Health Consultation

Technical Review
Inhalation Pathway Interim Measure Approach
Groundwater to Indoor Air Pathway

PHILIP SERVICES CORPORATION – GEORGETOWN SITE
CITY OF SEATTLE, KING COUNTY, WASHINGTON

AUGUST 9, 2005

Figure 1: IPIM Decision Tree⁷
 Philip Services – Georgetown Site
 Seattle, Washington

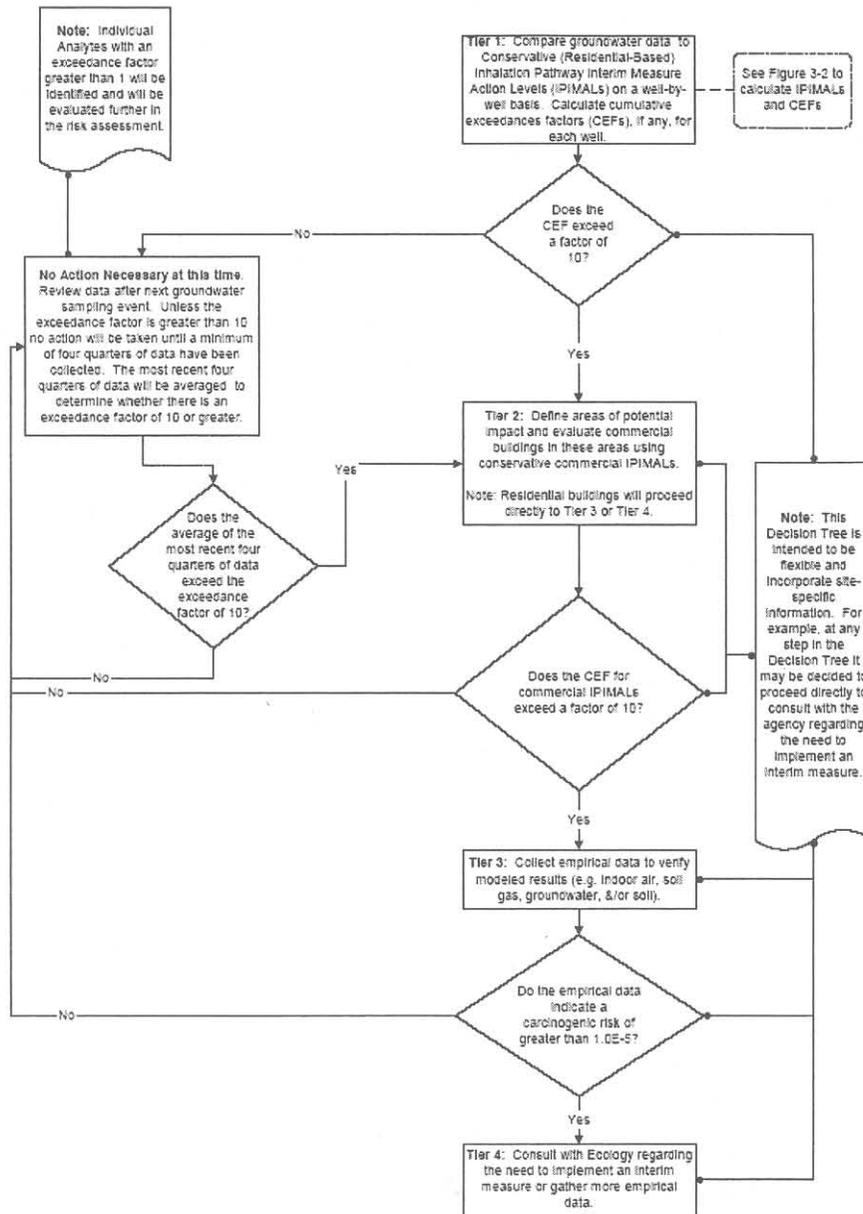
Groundwater results obtained from individual monitoring wells and direct push borings were divided by groundwater IPIMAL to obtain an exceedance factor (EF). Mainly groundwater monitoring wells screened across the water were used for this evaluation. In some cases, however, wells screened in the shallow aquifer but screened below the water table were used.

The EFs were then summed for each location to obtain cumulative cancer and non-cancer EFs (CCEFs and NCEFs, respectively). The cumulative EFs (CEFs) were then plotted and contoured to determine potential areas that could be affected by the groundwater. PSC selected residential buildings within the contours exceeding 10 CEFs for Tier 3 evaluation or to proceed directly to Tier 4, where interim actions (e.g. vapor vacuum systems) are designed and implemented. Commercial/industrial buildings within contours exceeding 10 CEFs or greater were considered for Tier 2 evaluation. A CCEF and NCEF of 10 indicate that exposure to indoor air concentrations near the sampling location could potentially result in a cumulative risk of 1E-05 or a hazard index (HI) of 1. Locations where CEFs were less than 10 were sampled during subsequent quarterly groundwater monitoring events.⁷

- Ecology and PSC should address whether the number and distribution of wells or other groundwater sampling points (e.g. new direct push) are adequate for conducting the Tier 1 evaluation since this approach is being considered as part of the final actions at the site. If the monitoring network is inadequate, it should be expanded as appropriate.

- Some indoor air sampling should be conducted by PSC at buildings where CCEFs and NCEFs are less than 10 to confirm that PSC's approach is correctly identifying buildings where VOC contaminated groundwater poses an indoor air health threat. Ecology and PSC should consider a subset of vulnerable subset of such buildings, based perhaps on structural characteristics, for this confirmation sampling.

- Some wells screened below the water table were used for the Tier 1 evaluation where no water table wells existed. DOH recommends that Ecology and PSC consider adding water table wells or other types of water table sampling points (e.g. direct push) at these locations if these are appropriate monitoring points and it is likely that water table COPC concentrations exceed levels measured at the lower depths.

- Ecology and PSC should conduct a building survey at all buildings where no vapor mitigation systems have been installed, and the buildings overlie or are located near the shallow VOC contaminated groundwater, to ensure that there are no buildings that are particularly vulnerable to the migration of VOCs from the groundwater to indoor air (e.g. crawlspace homes where crawlspace vents are blocked off or no crawlspace vents exist; homes with exposed soils in the basements).

Commercial/industrial locations that exceeded a groundwater CEF of 10 were evaluated again in Tier 2. However, the steps appear to be the same as Tier 1 except that PSC notes that locations exceeding a CEF exceeding 10 will be further evaluated under Tier 3 of the IPIM decision tree.⁷

The purpose of Tier 3 is to collect property specific data (e.g. indoor air, soil gas, groundwater, and/or soil) at locations where groundwater CEFs exceeded 10 in Tier 1 or 2 to determine if interim measures are necessary. As done in the GIVF step above, indoor air sample results are adjusted for background contributions. These adjusted results are then divided by residential and commercial/industrial indoor air IPIMALs to obtain EFs and CEFs as described in Tier 1, above. Only COPCs detected in groundwater and soil gas are included in the Tier 3 evaluation because it is assumed that this represents a completed pathway.⁷ This appears to be a reasonable approach if groundwater and soil gas sampling are conducted appropriately. However, it was determined in early 2005 that there are some problems with PSC's soil gas sampling method, resulting in an underestimation of the contaminant levels in soil gas.

Ecology reports that it re-evaluated Tier 3 decisions made prior to discovering that there were some problems with sub-slab soil gas sampling and determined they had not erroneously concluded that a vapor mitigation system was unnecessary at any location (E-mail message from Ed Jones, Ecology to Barbara Trejo, DOH, June 2, 2005).

PSC's Tier 1 approach seems reasonable if the following recommendations are addressed by Ecology and PSC.

Recommendation: Ecology and PSC should resolve the soil gas sampling problems for future evaluations. In addition, Ecology and PSC should ensure that sampling intervals for indoor air and ambient air are consistent with planned sampling intervals (e.g. 24 hour samples for residential structures).
